**IRREGULARITIES AND ANOMALIES RELATING TO NUCLEAR REACTOR  
PRIMARY COOLANT CIRCUIT COMPONENTS INSTALLED IN JAPANESE  
NUCLEAR POWER PLANTS**

**PART I – FRENCH CARBON ANOMALY CORRELATION TO JAPANESE NUCLEAR  
POWER PLANTS**

Client: **GREENPEACE JAPAN**

Ref N° **R3235-R1**

FIGURE 2 - EPR RPV SHELL

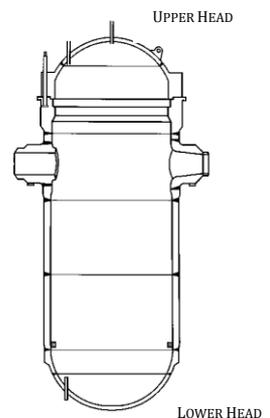
The preliminary findings of the FA3 testing and evaluation programme strongly pointed to faults and inconsistencies in the manufacturing processes deployed at the Creusot Forge, particularly in the casting and subsequent upset forging from a single, top-cast ingot.[6] This process was known to give rise to heterogeneity of the steel alloy in the form of localised positive macrosegregated zones of excess carbon content, usually located at the top end of the cast ingot or billet but which could be effectively managed by cropping and discarding the affected section of macrosegregation. However, if the discard amount was not fully effective then subsequent hot working to form the component shell retained the excess carbon zone as shown typically by FIGURE 2.

FIGURE 5: PLAQUE TUBULAIRE 1300 MWE – CARTOGRAPHIE DE CARBONE

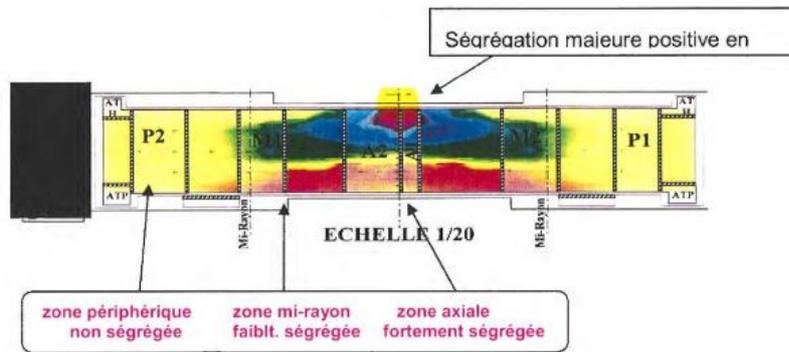
- A) Referring to the tubesheet featured in FIGURE 5 of the AREVA document *Calottes de cuve FA3 – Conception et fabrication*, DO2-PEE-F-15-007 Rev A, 24 April 2015 please

- iii) provide the manufacturing source of the tubesheet (ie Creusot, JSW, etc);
      - iv) if similar replicate tubesheets have been provided by all suppliers (Creusot, JSW, etc) for similar analysis;

#### ASN TEST RESULTS FOR A UNKNOWN-SOURCED SG ELLIPTICAL DOME[10]

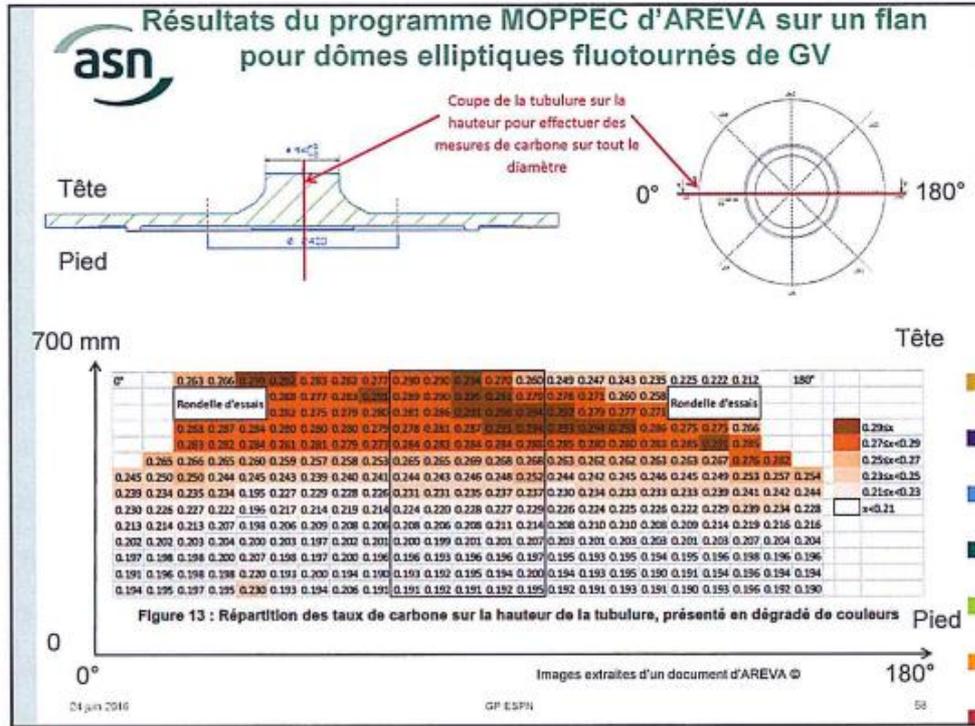
- c) **JSW Elliptical Domes:** Examination and destructive testing of a replicate elliptical dome revealed the presence of a macrosegregation zone of excess carbon (~0.29%) and tests yielded below specification material toughness (Charpy) values.

However, the source of the particular replicate examined is not available so the risk of macrosegregation cannot be definitely allocated to JSW SG elliptical dome components.

- A) Referring to the elliptical dome featured in page 54 of the ASN presentation of the ASN presentation *Ségrégations majeures positives résiduelles du Carbone Composants forgés du parc en exploitation d'EDF* 24 juin 2016, please provide the information relating to elliptical dome components as requested above under item 2), A), i) to vii).
